# City of Alexandria, Virginia

## MEMORANDUM

**DATE:** JANUARY 17, 2024  
**TO:** MAYOR WILSON AND MEMBERS OF CITY COUNCIL  
**FROM:** KARL MORITZ, DIRECTOR; DEPARTMENT OF PLANNING & ZONING  
**SUBJECT:** DSUP #2023-10009, REZ #2023-00003, & MPA #2023-00002/301 North Fairfax Street

SHEET NUMBER:  
**A-202**

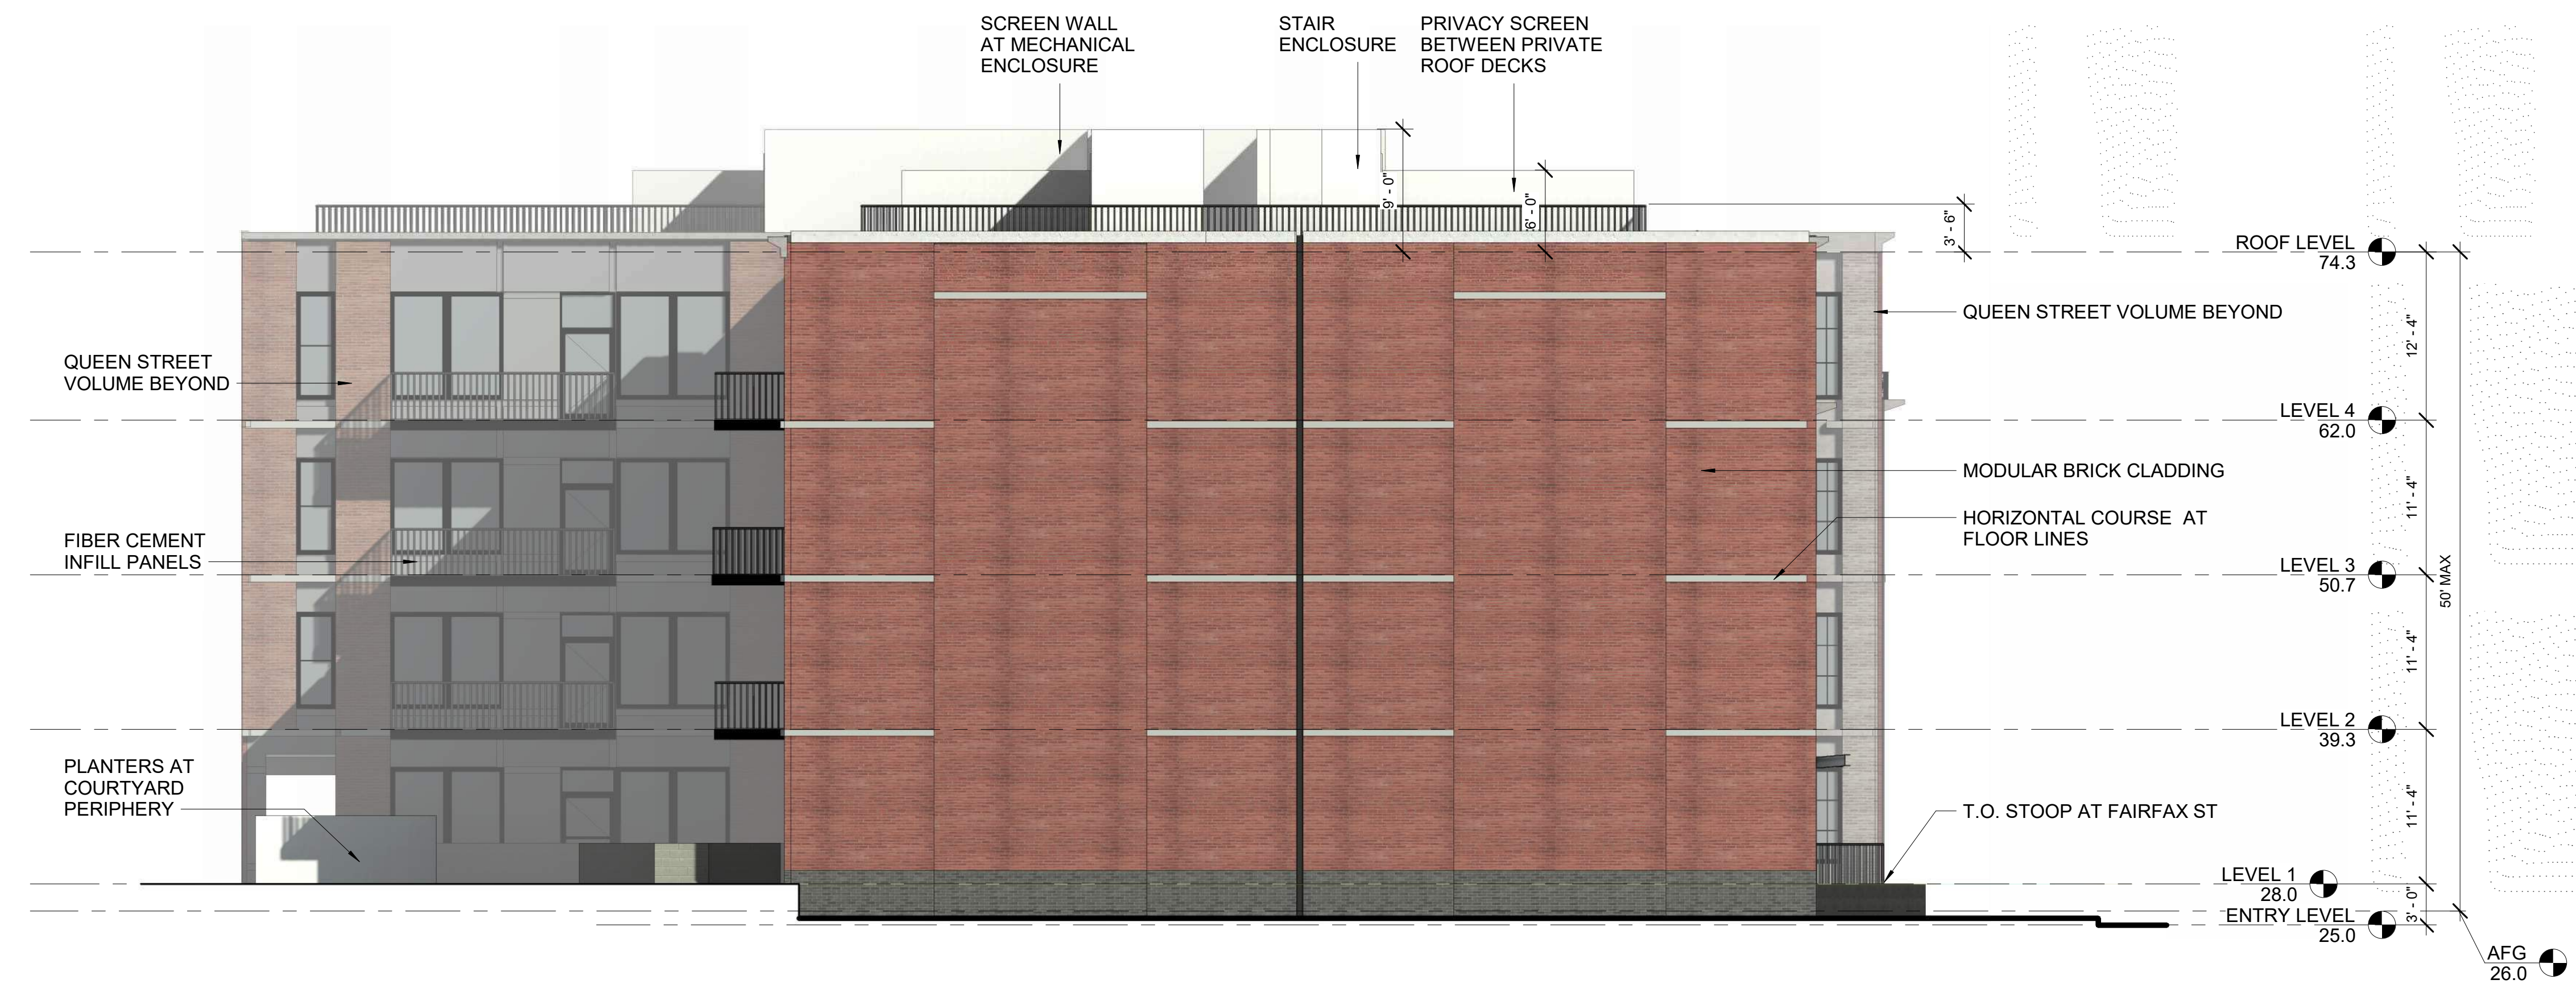
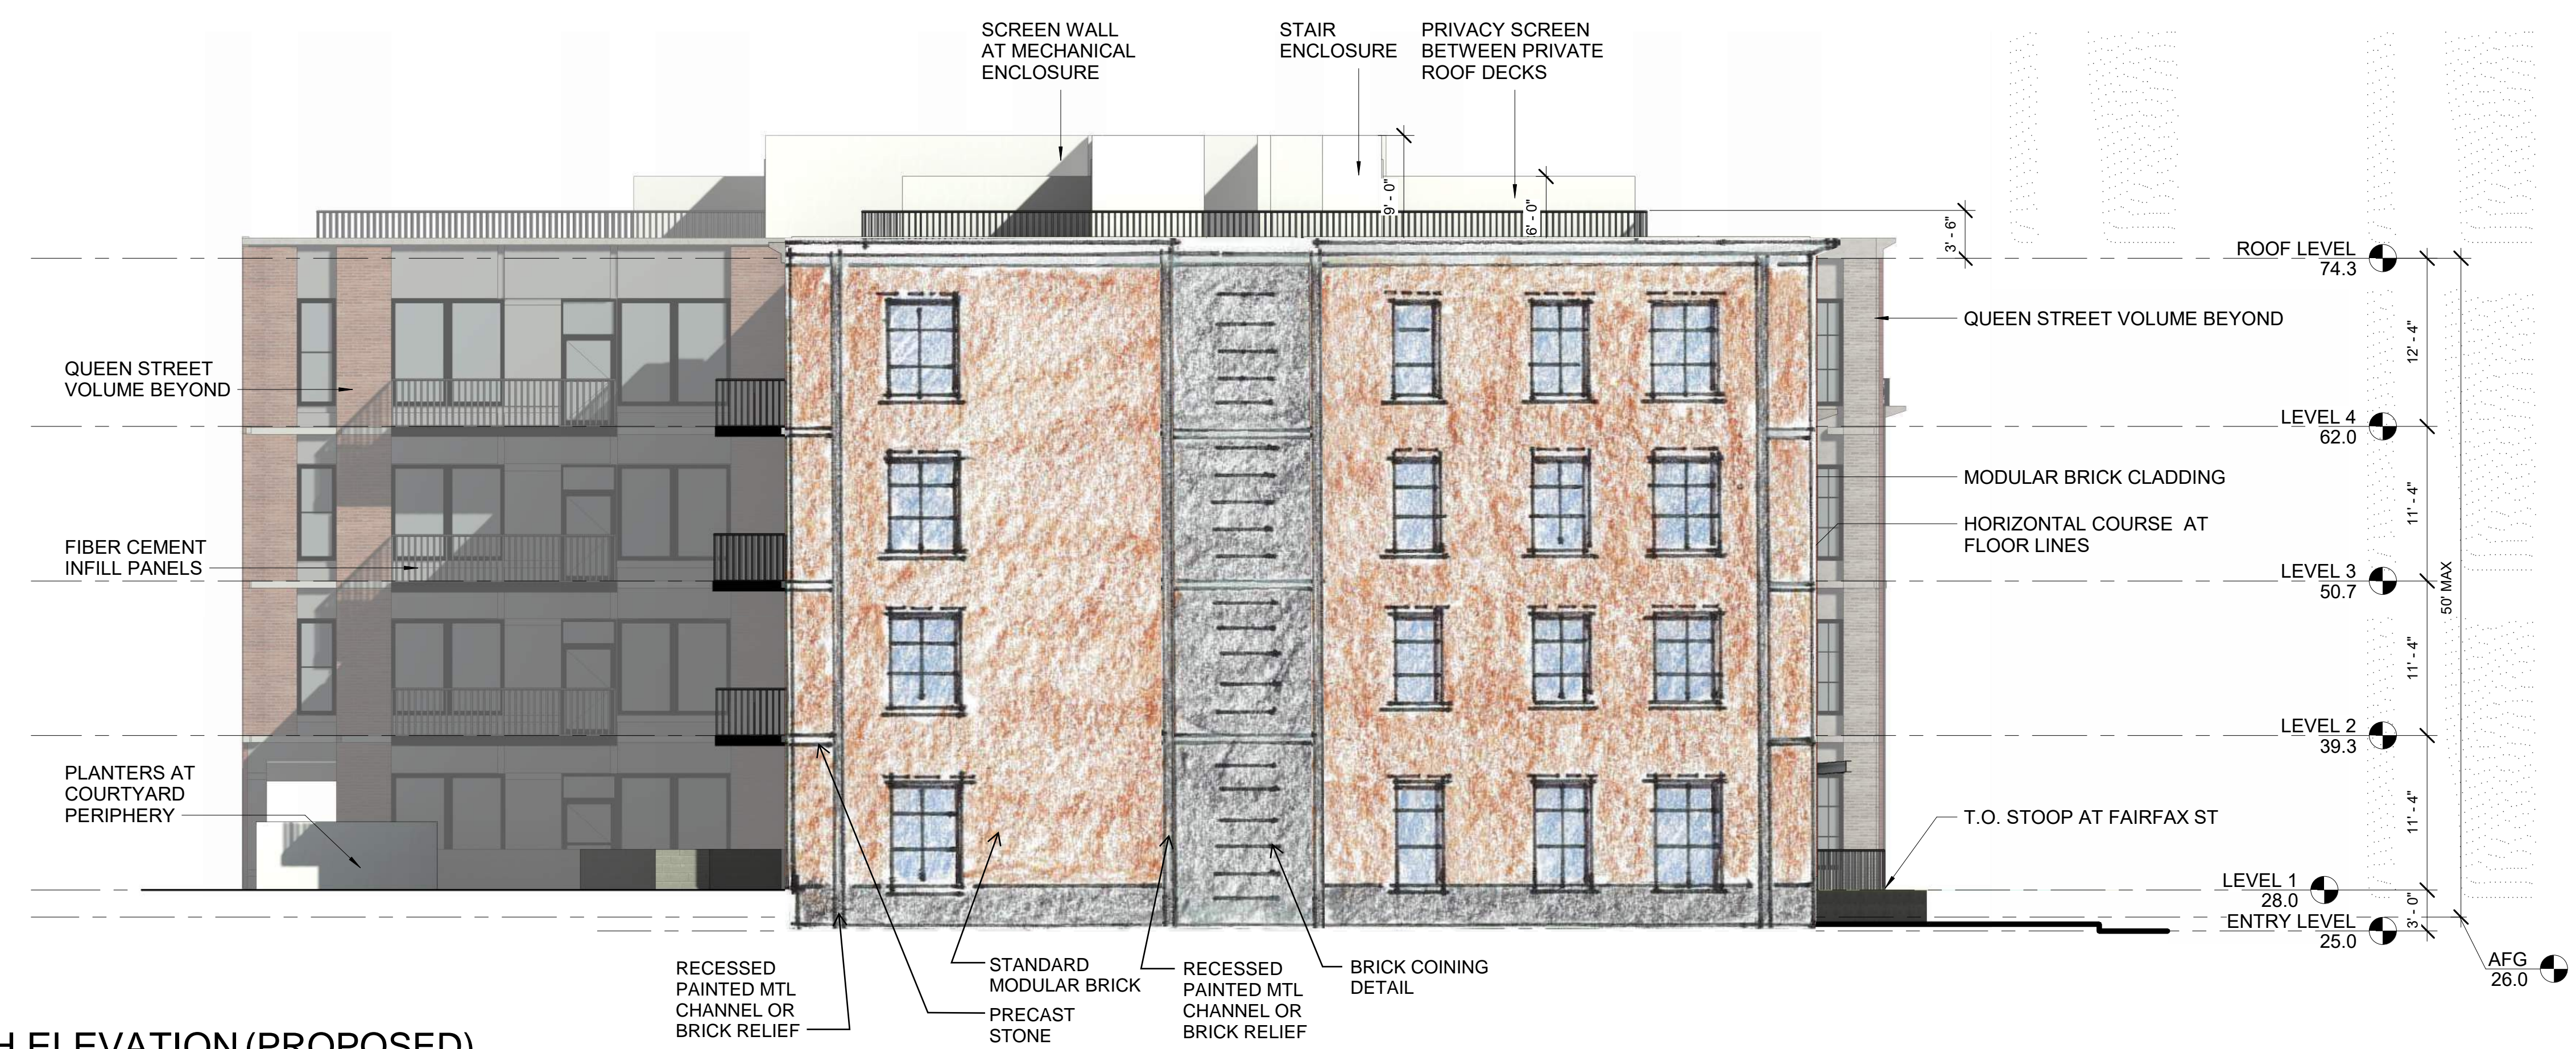
The attached *Exhibit A* shows changes to the building design proposed by the applicant in response to concerns raised about the lack of a building break through the block at the north property line as well as the blank walls proposed at both the north and east elevations. The building will be set back approximately 5 feet from the north property line to provide a physical and visual break through the site toward the river. The floor area will remain the same and be shifted along the North Fairfax Street elevation. The building will still have setbacks and entry stoops along North Fairfax Street. Due to the setback, windows will be added to the façade of the north elevation, transforming this portion of the building from what was previously a blank wall. The building also previously included a blank wall at the east elevation and the applicant has proposed additional architectural refinements to provide a more visually interesting design. Staff supports the proposed revisions to the building design and the setback and has proposed condition language below.

9. The building design, including the appearance, color, and quality of materials; final detailing; three-dimensional expression; and depth of all plane changes, shall be consistent with the elevations dated August 22, 2023 **as revised by Exhibit A, dated January 12, 2024, showing updated revisions to the north and east elevations and a setback from the north property line, and** the following conditions. Provide this information regarding materials and design to the satisfaction of the Director of P&Z prior to Final Site Plan release: (P&Z) (Code) \*
